ECN/PCN No.: 3500

For Manufacturer

Product Description: CERAMIC SMD CRYSTAL	Abrakon Part Number / Part Series: ABM8	<input checked="" type="checkbox"/> Series
Affected Revision: Rev. AA	New Revision: Rev. AB	<input type="checkbox"/> Part Number
Application:		<input type="checkbox"/> Safety
		<input checked="" type="checkbox"/> Non-Safety

1. Mechanical Dimensions & Tolerances (Bottom View)

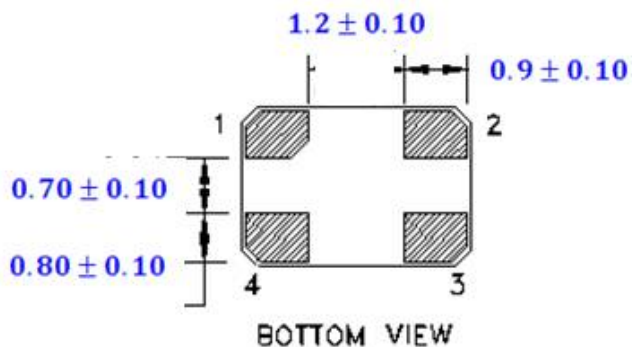
Standard product series review and upgrade. Due to SMD package material availability, product mechanical dimensions and tolerances were adjusted, a revised landing pattern was implemented to increase ease of soldering, and an alternate pad is utilized for the chamfer pad location.

Change Declaration:
Mechanical Dimensions and Tolerances:

The package mechanical dimension revisions do not impact the mechanical performance of the device.

2. Landing Pattern

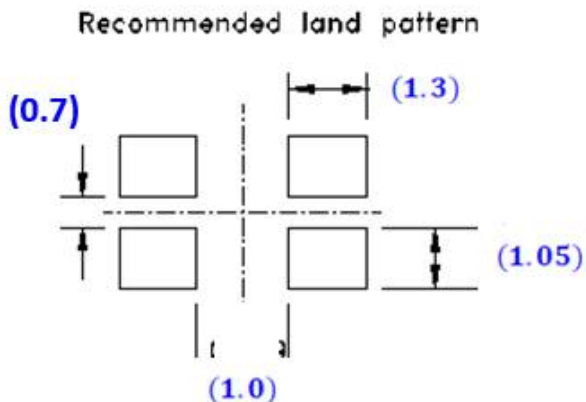
There is no impact on the PCB layout/landing pattern for customer's existing boards. The new landing pattern was implemented to increase ease of soldering.

3. Chamfer Location

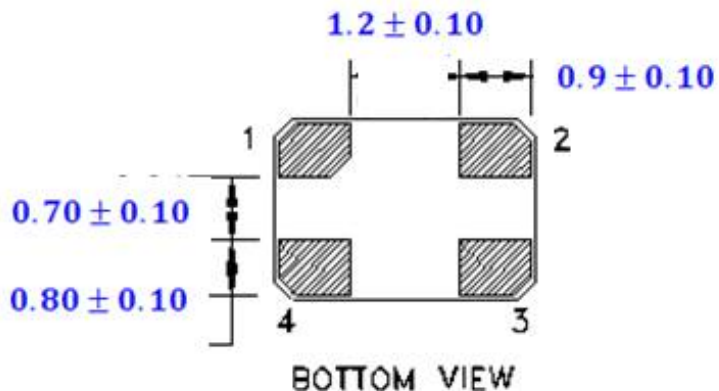
Note:

Due to material availability, the chamfer could be located on pin #1, 3, or 4. Be advised that the chamfer location has no impact on the electrical performance of the device.

The package chamfer pad location revision does not impact the mechanical or electrical performance of the device.
